1st Review
PRCCP20240569
June 2024

ASH DEVELOPMENT, LLC
EAST TOWN CROSSING
PUYALLUP, WA

PAVEMENT MARKING &
SIGNING PLANS - PHASE 1

TRAFFIC SIGNAL PLANS – PHASE 1

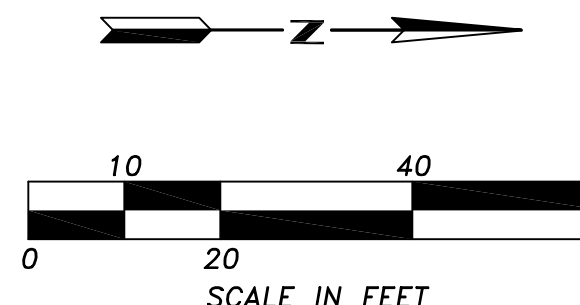
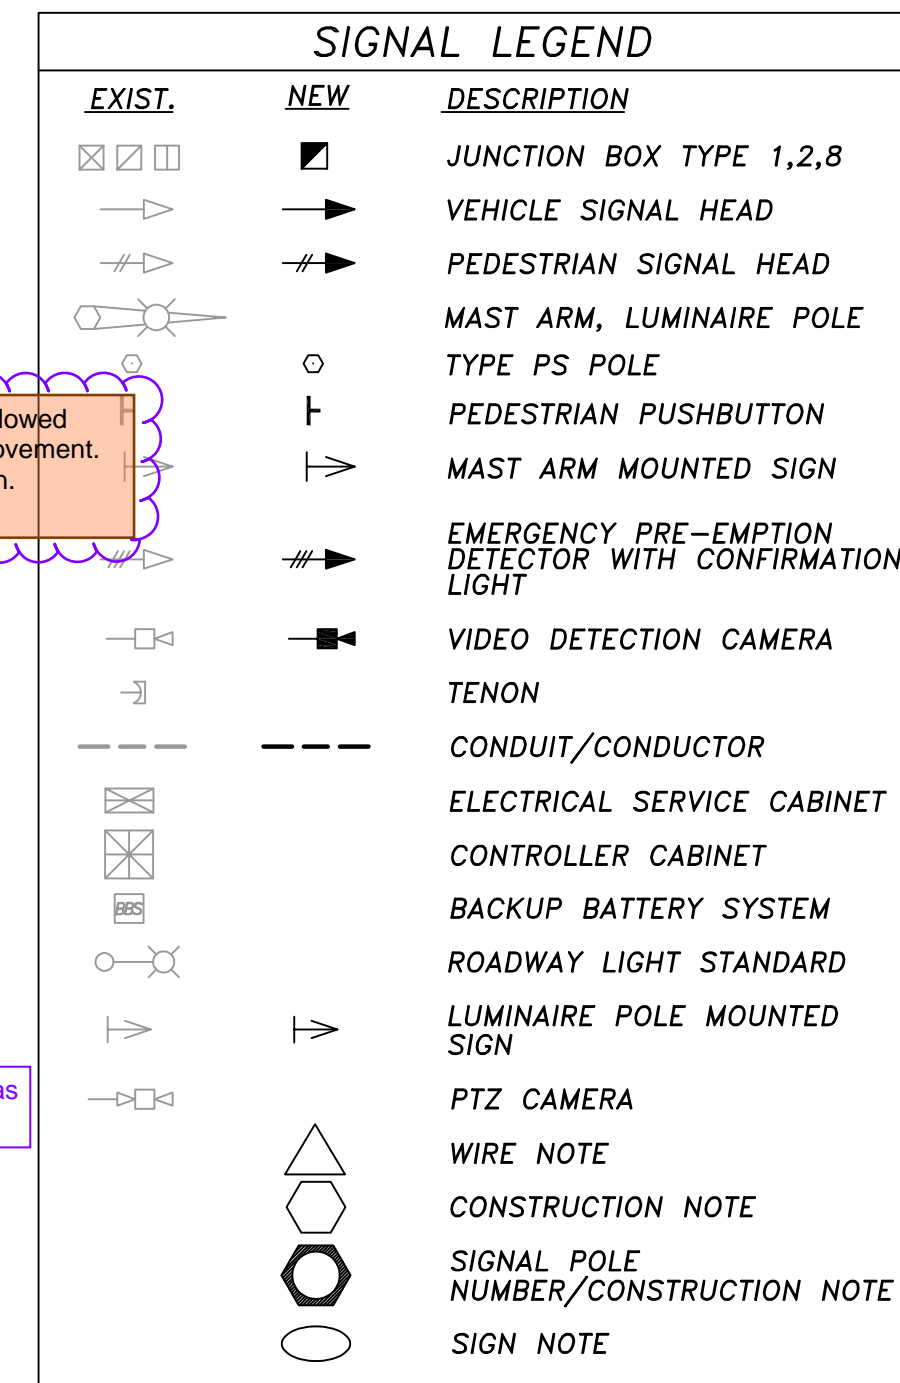
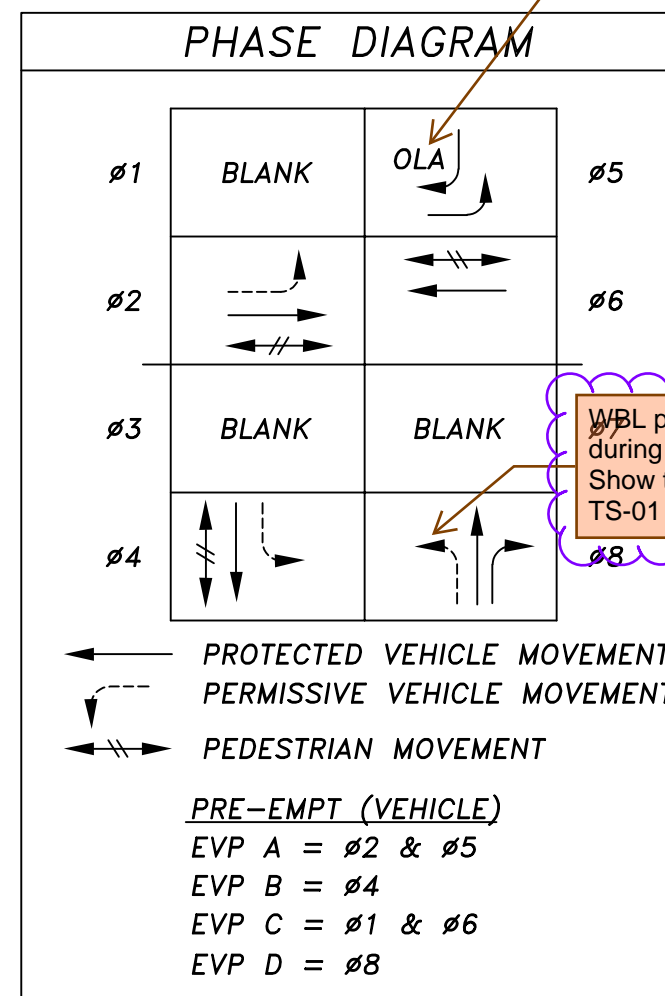
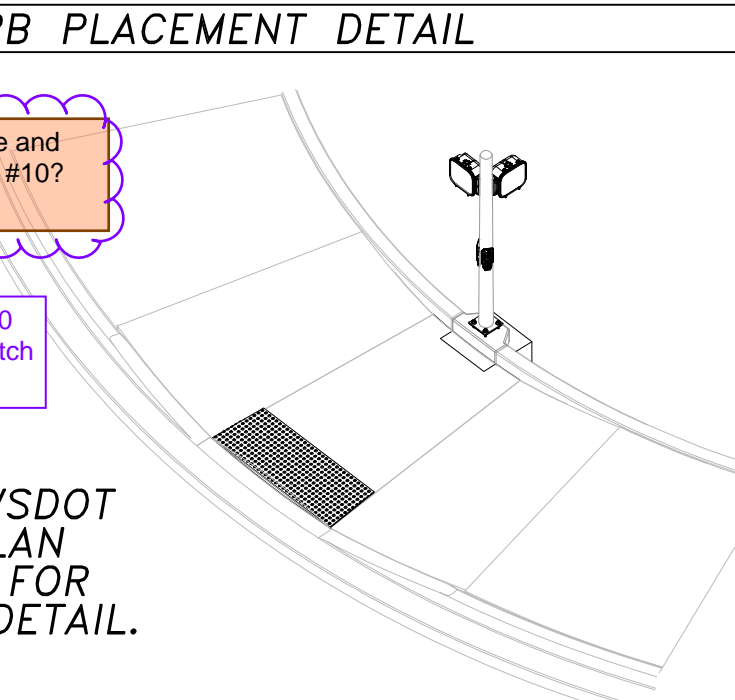
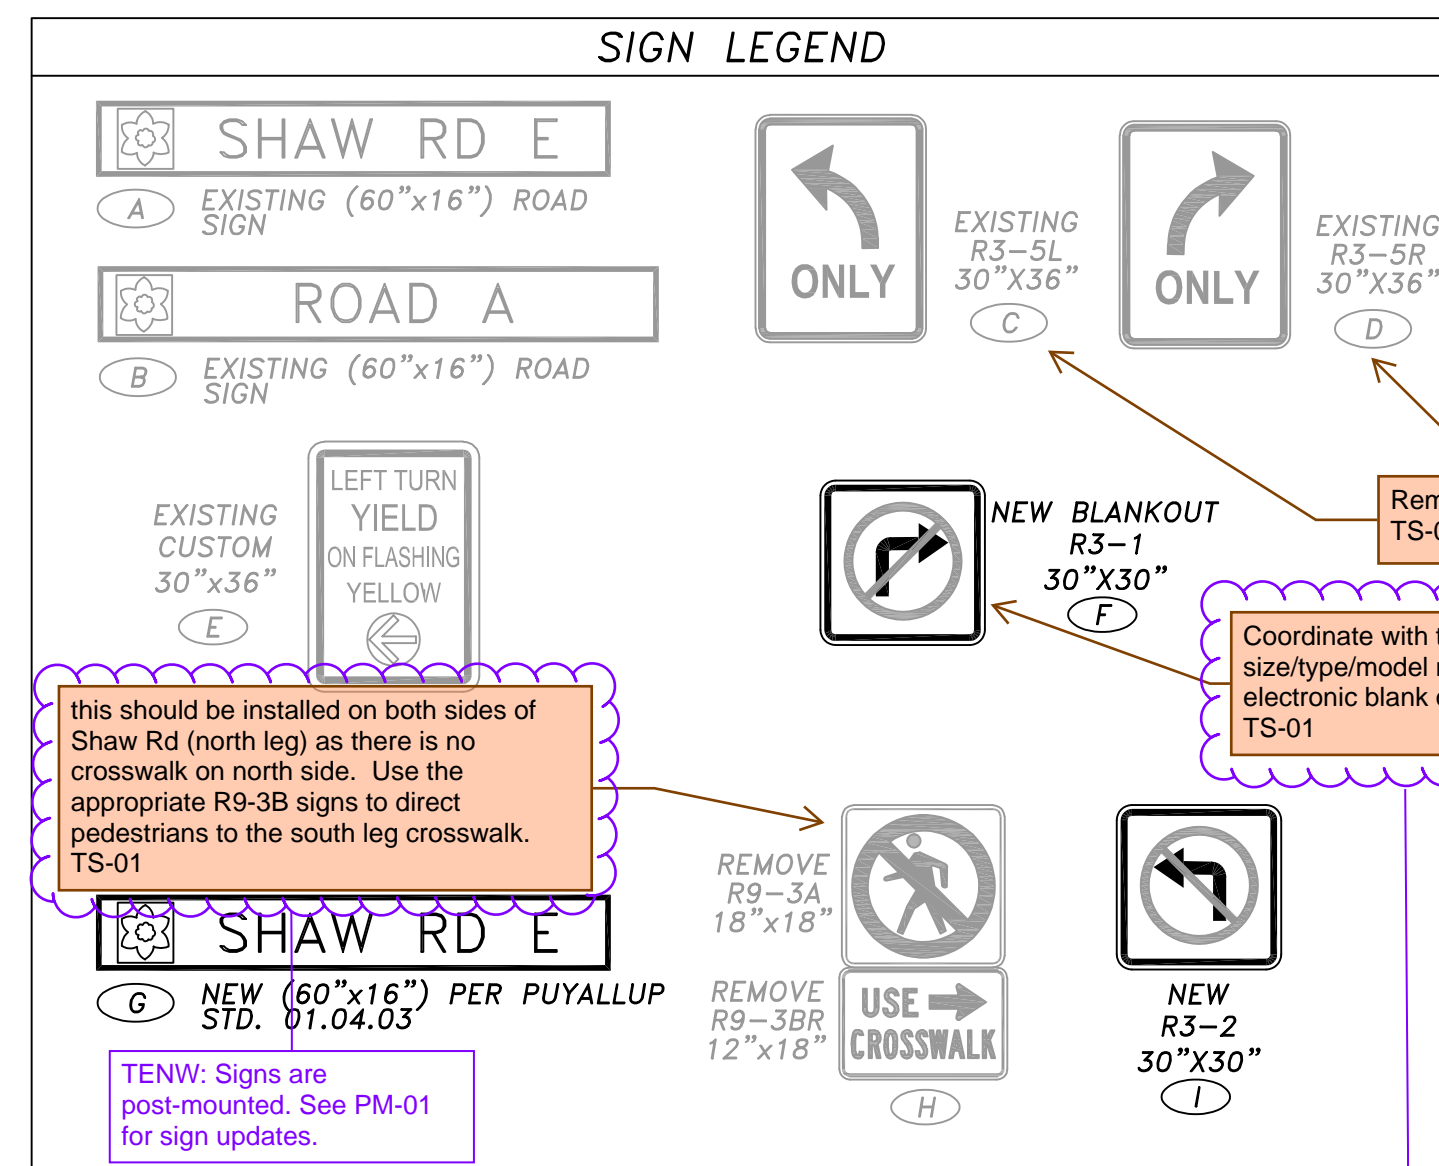
- TENW:
- City did not provide acceptable power source for flashing beacons. Flashing beacons to remain solar
 - Flashing beacon location updated per discussion with City in meeting 11/20.
 - Advance warning signs updated per MUTCD.

- TENW: Signs are post-mounted. See PM-0 for sign updates.
